SERVICE LETTER NO. SL115-45/2

ATA-Code: **32-20 Nose landing gear**

**G 115E
G 115EG**

View C - C

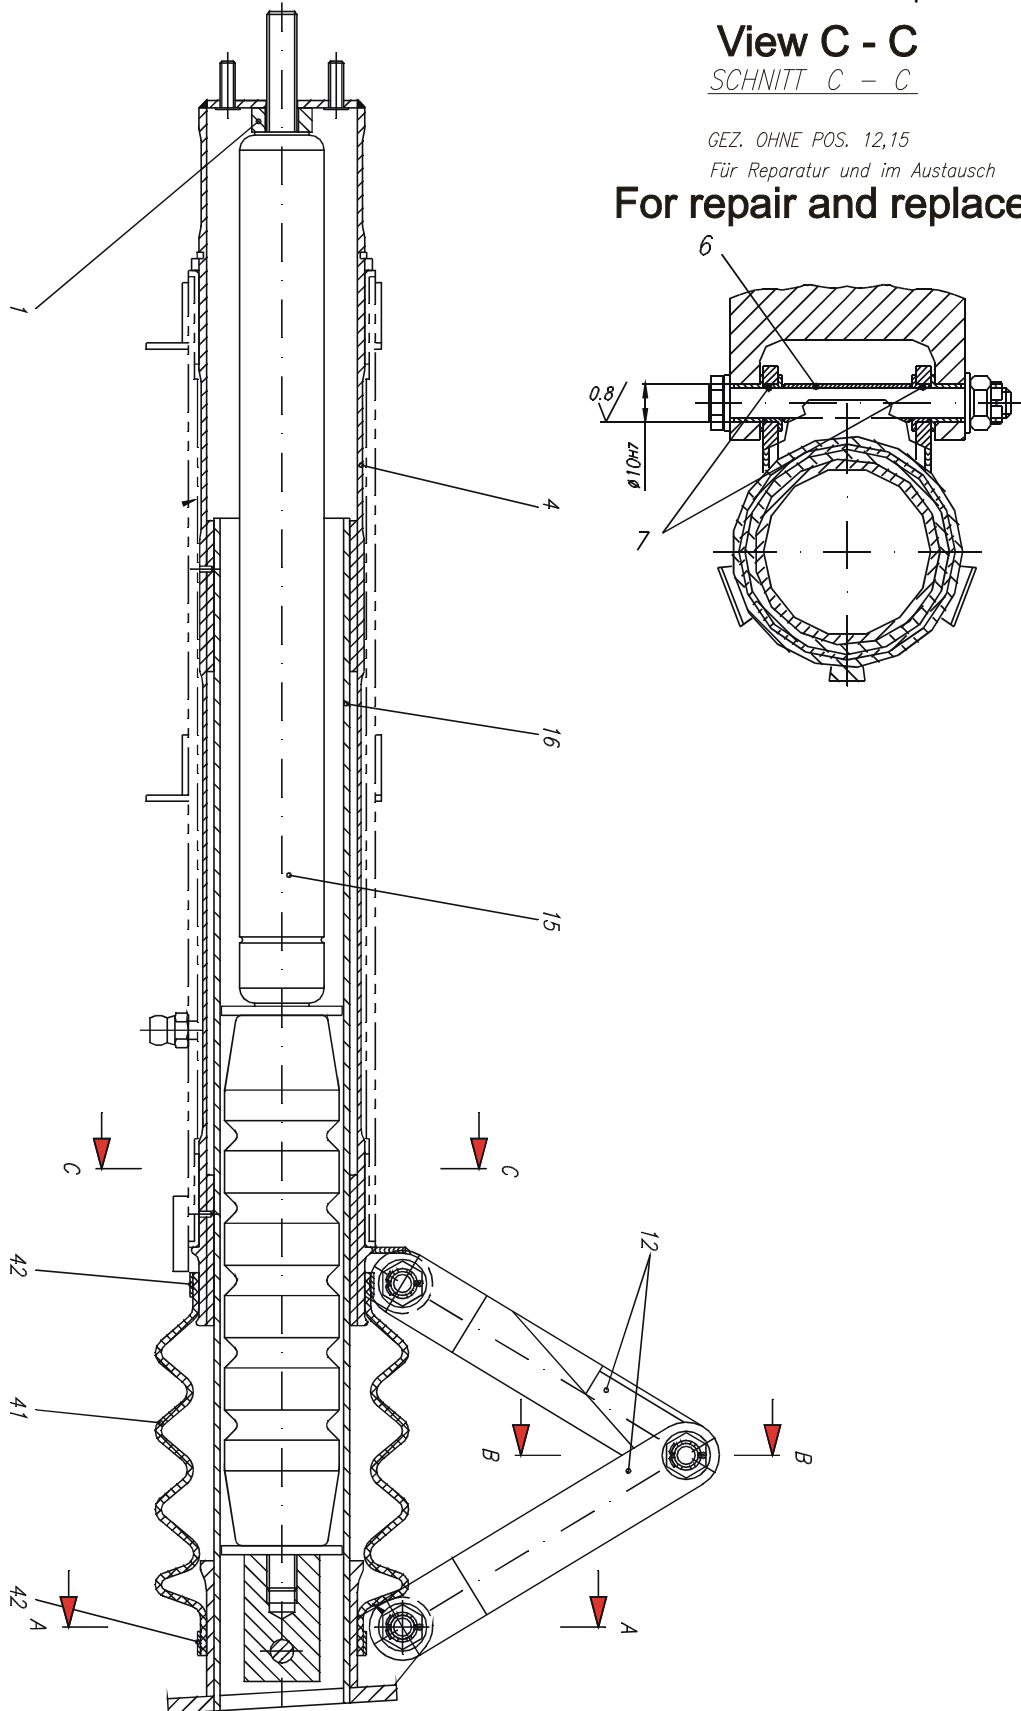
The design of the nose landing gear was improved to allow the nose landing gear to be bushed at various positions.

- Remove the nose landing gear IAW Maintenance Manual Chapter 32-20
- Replace bushes as required on the flange P/N 115C-5204 or centre tube P/N 115E-5202 IAW the drawings below or manufacturers drawing 115E-5204

- Remove the nose landing gear IAW Job Guide 1TG115EG-2-32JG-001, Chapter 32-20
- Replace bushes as required on the flange P/N 115C-5204 or centre tube P/N 115E-5202 IAW the drawings below or manufacturers drawing 115E-5204

Für Reparatur und im Austausch

For repair and replacement
